STATE OF OHIO DEPARTMENT OF TRANSPORTATION

WAR-S RIVER & S MAIN NS

INSTALL NEW TRAFFIC SIGNALS AT W 6TH ST/S RIVER ST AND W 6TH ST/S MAIN ST INTERSECTIONS FOR RAILROAD PREEMPTION AND INTERCONNECTION WITH NORFOLK SOUTHERN GRADE CROSSINGS DOT #524892A AND 524894N. INSTALL CURB RAMPS AROUND THE W 6TH ST/S RIVER ST INTERSECTION AND ON THE SOUTH SIDE OF THE W 6TH ST/S MAIN ST INTERSECTION. INSTALLATION WILL INCLUDE ADA AND MUTCD COMPLIANCE. THE PROJECT LENGTH IS 0.10 MILES.

PROJECT ID
115153

DESIGN DESIGNATION

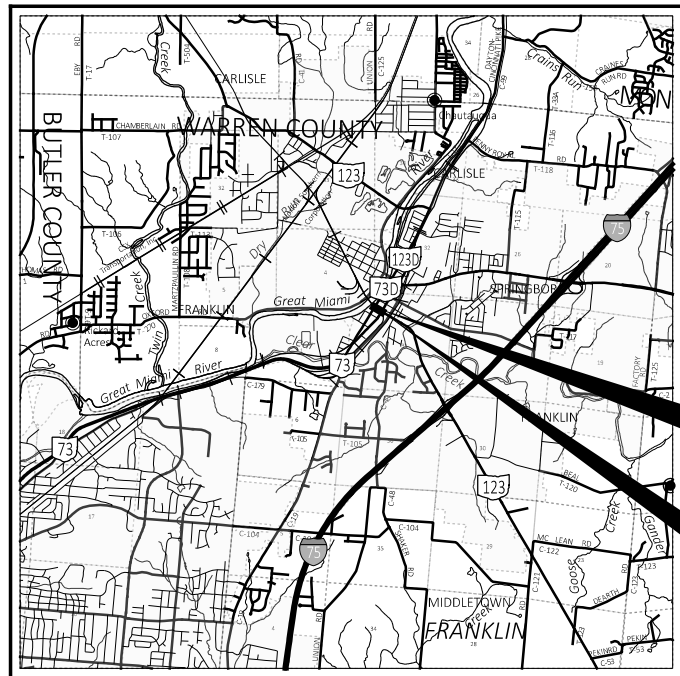
SR73D? is this why on the NHS?

SIGNING AND MARKING PLANS
WEST 6TH STREET

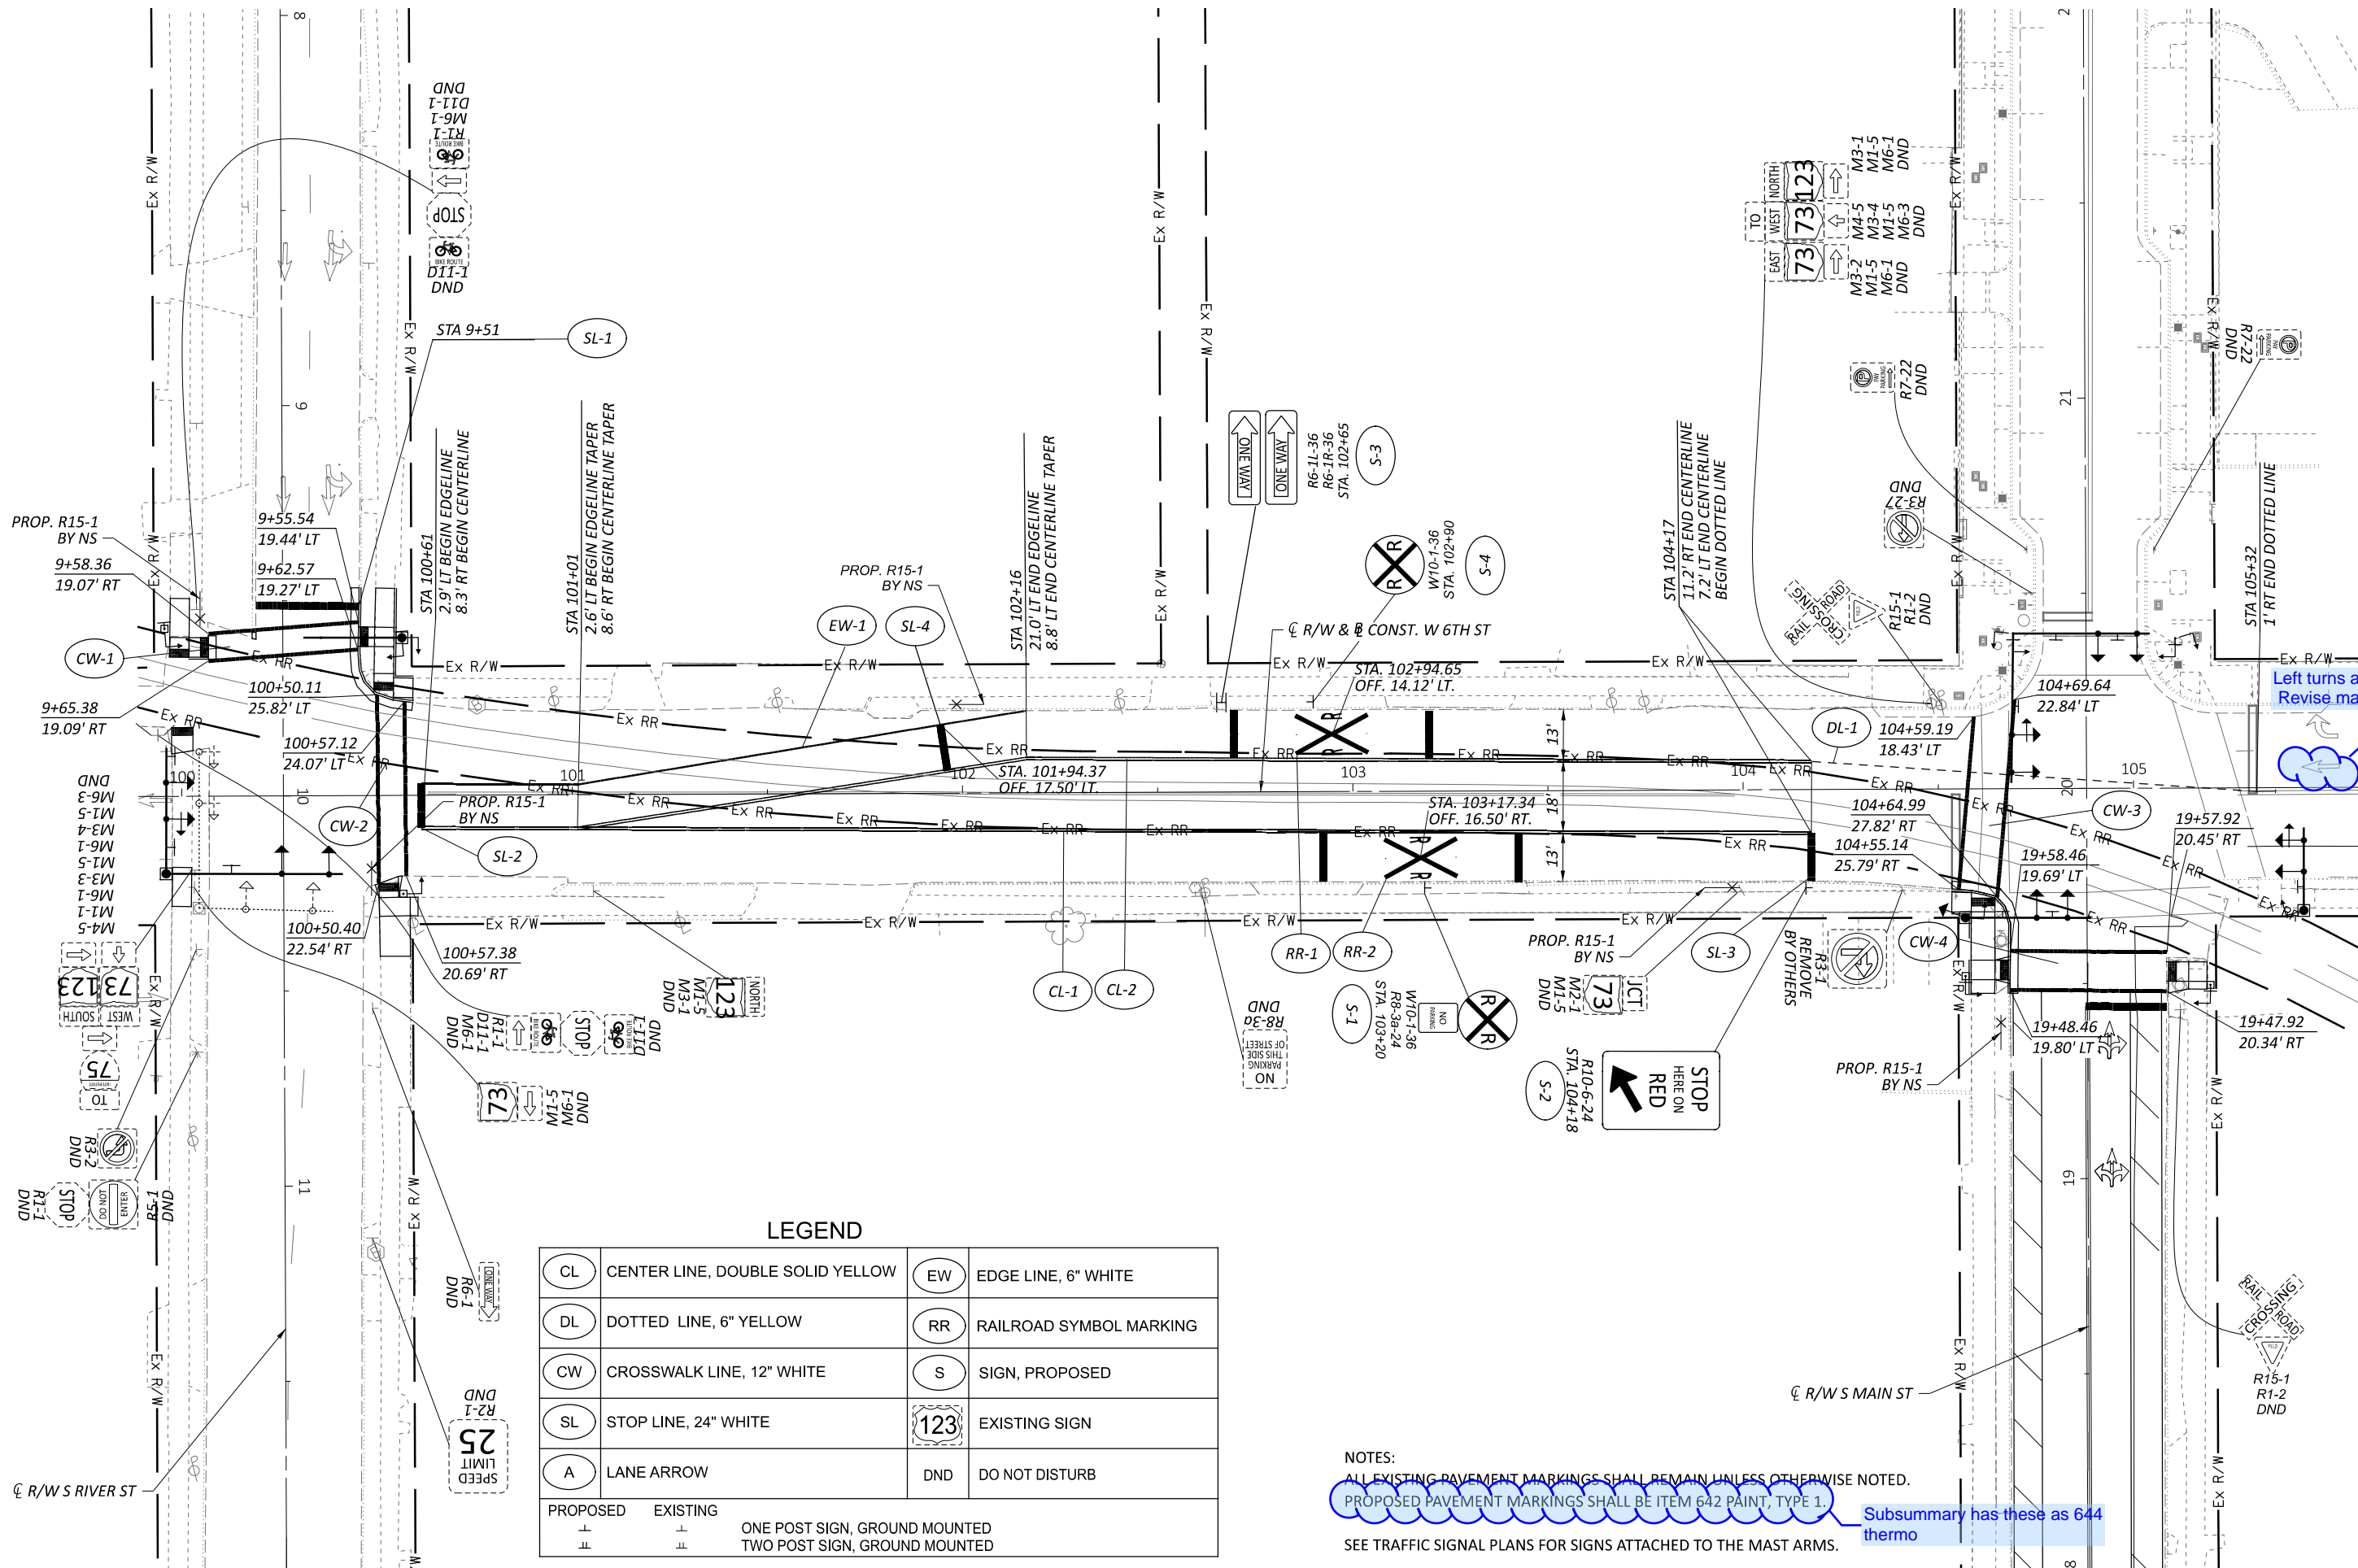
Left turns are not allowed
 Revise marking

SIGNAL HEADS

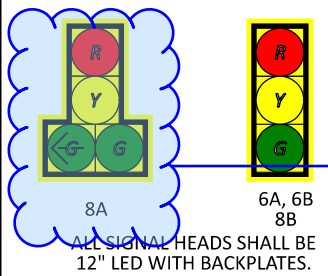
Response to Designer: This head arrangement is not common around here, to my knowledge, I would only use it if overhead clearance was an issue, particularly with retrofitting an existing signal. Since this is a new build, I would prefer a 4-section vertical head, but this is a City signal, so their preferences will take precedence here.

SOUTH RIVER ST & WEST 6TH ST
TRAFFIC SIGNAL PLAN

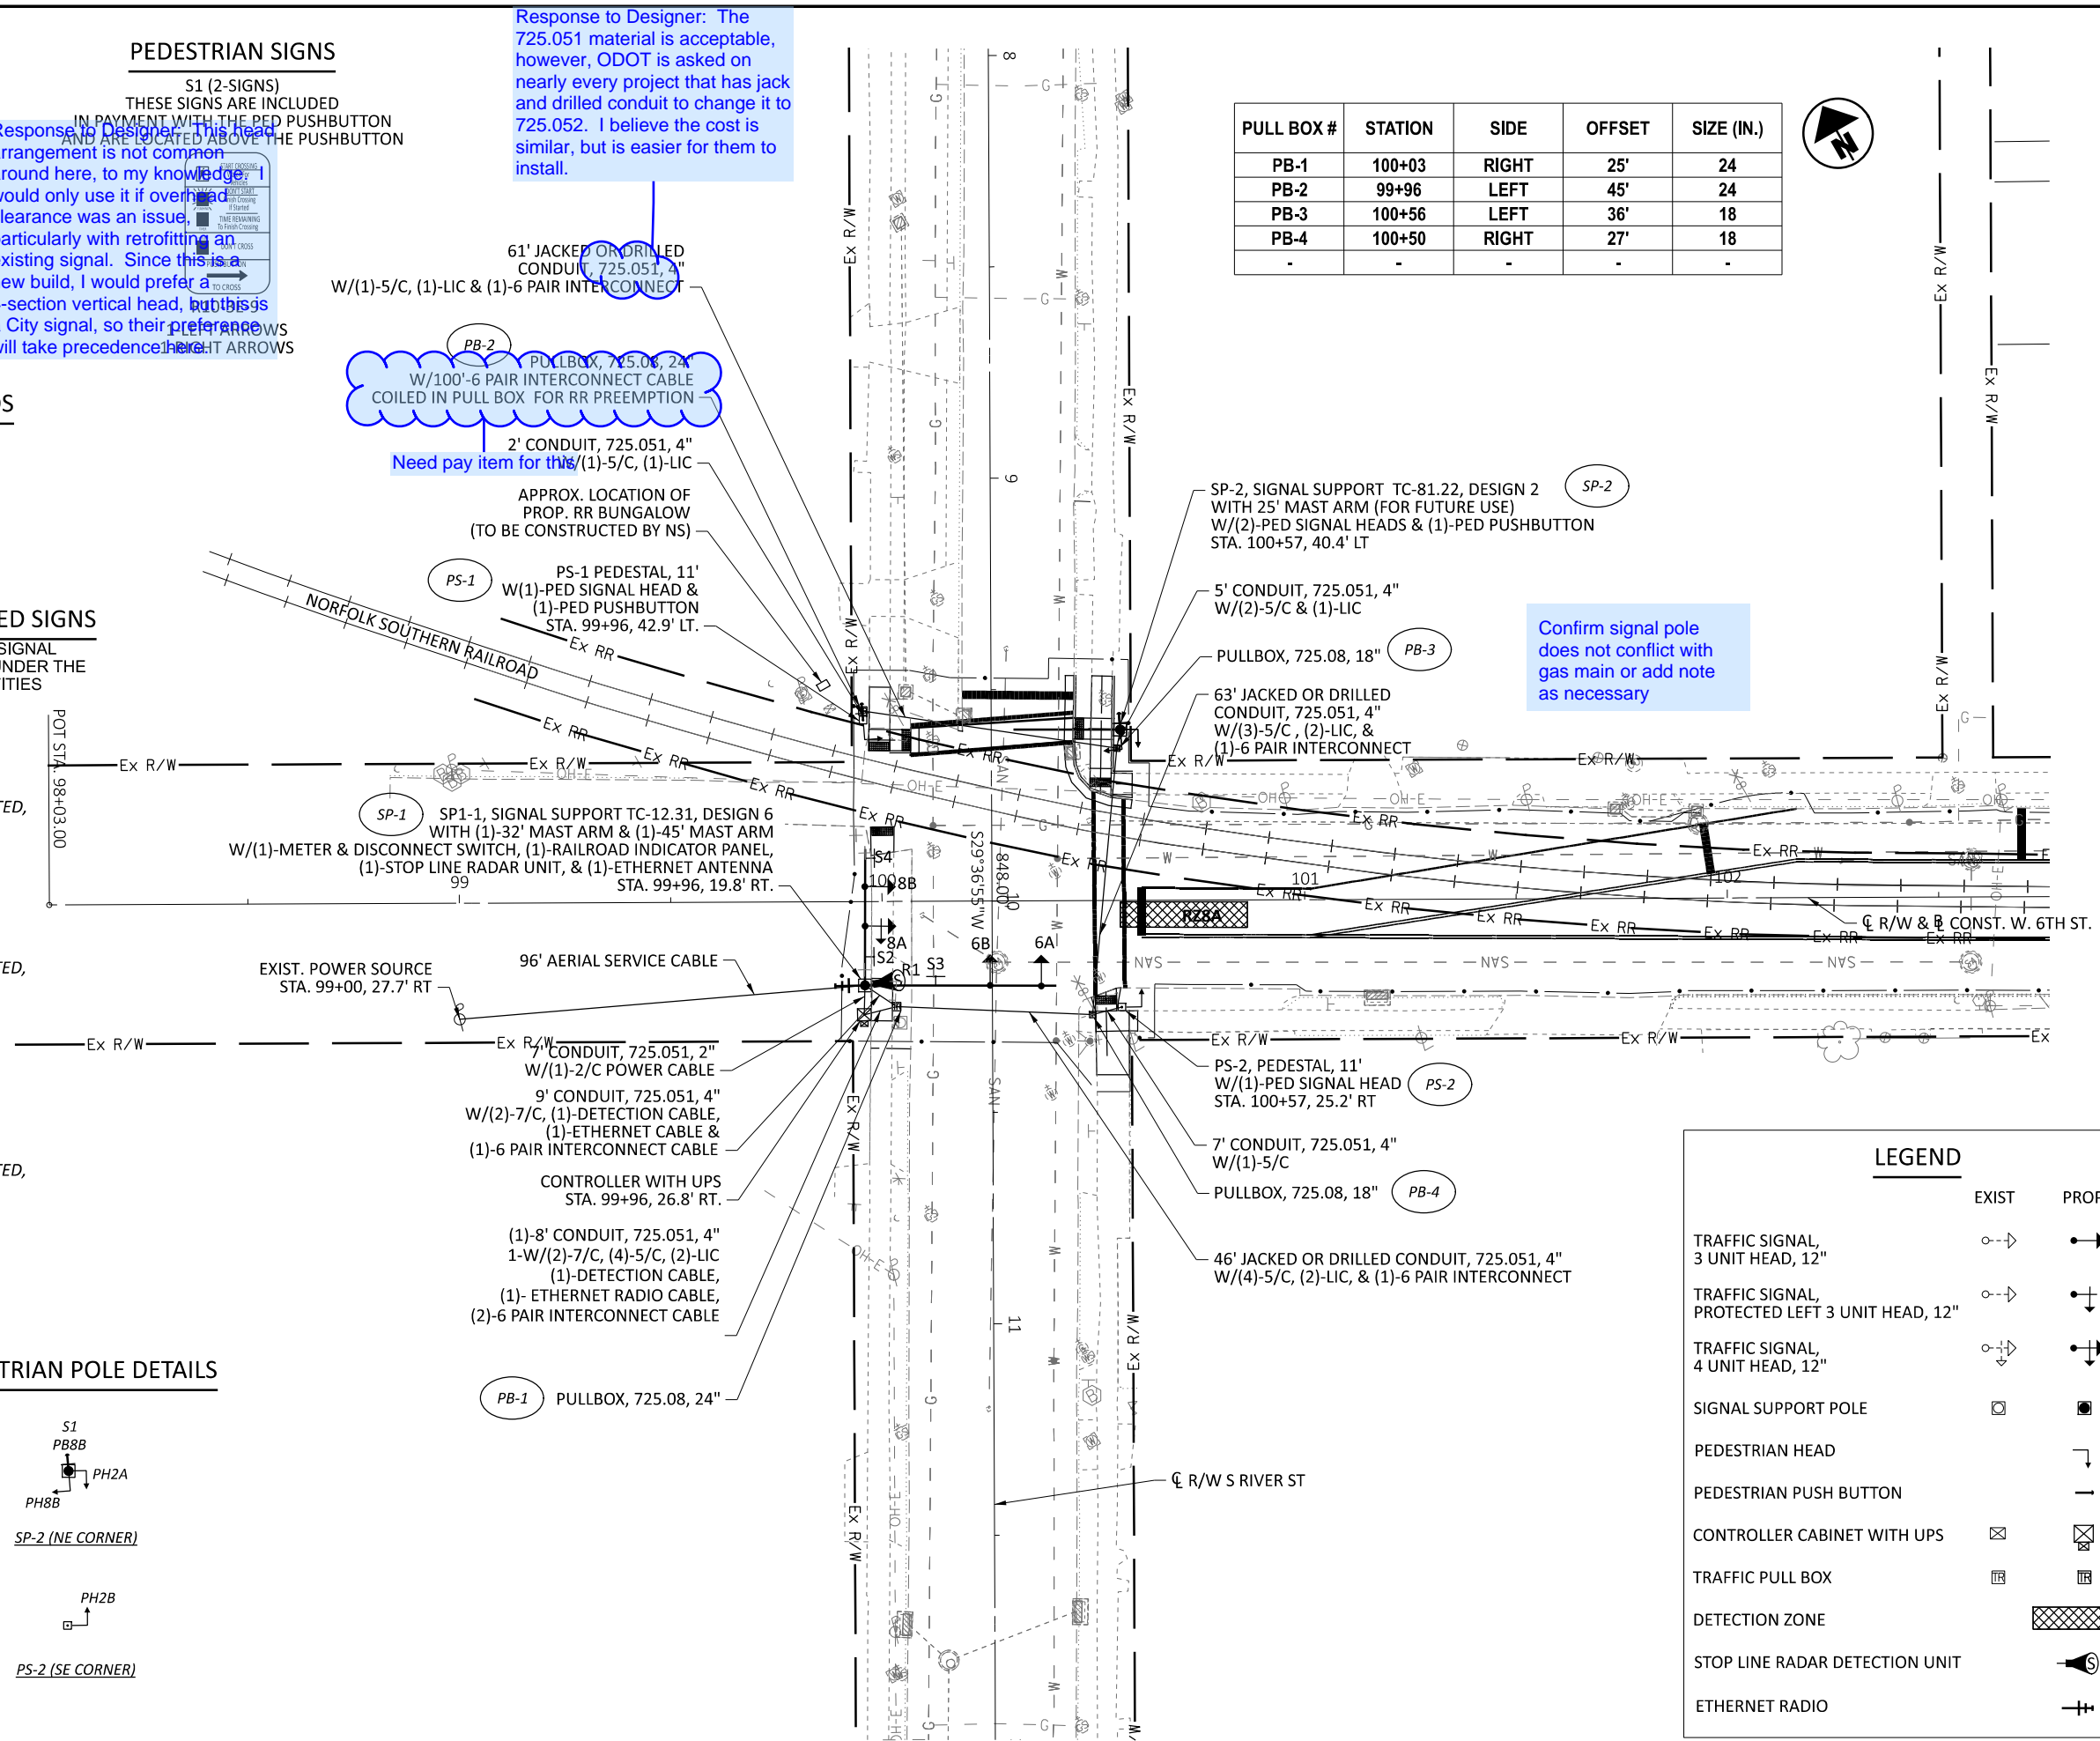
Confirm signal pole does not conflict with gas main or add note as necessary

MAST ARM TABLE

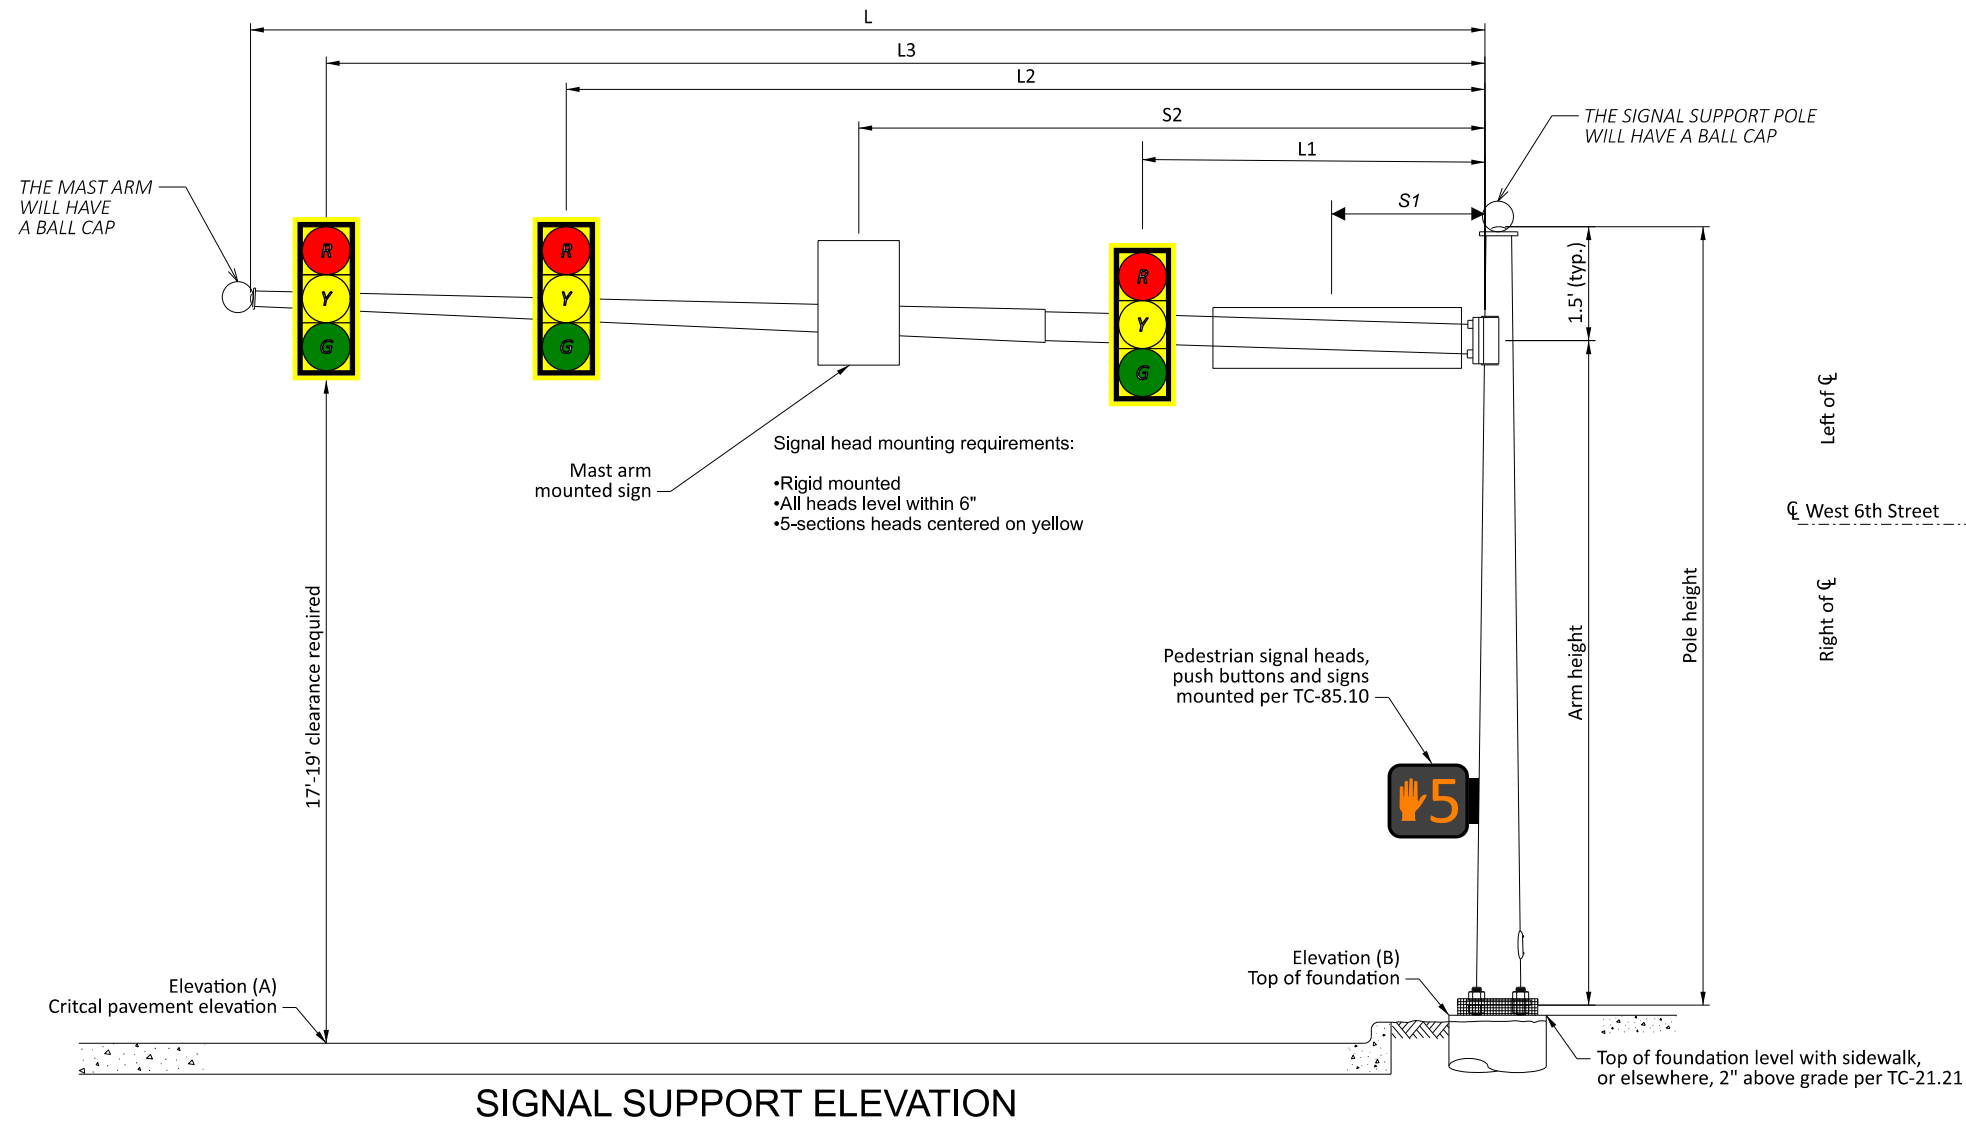
Arm A data should come first. It looks like the labels for Arm A and Arm B were switched from the previous submission, but none of the data. Make sure the data table matches the calculations
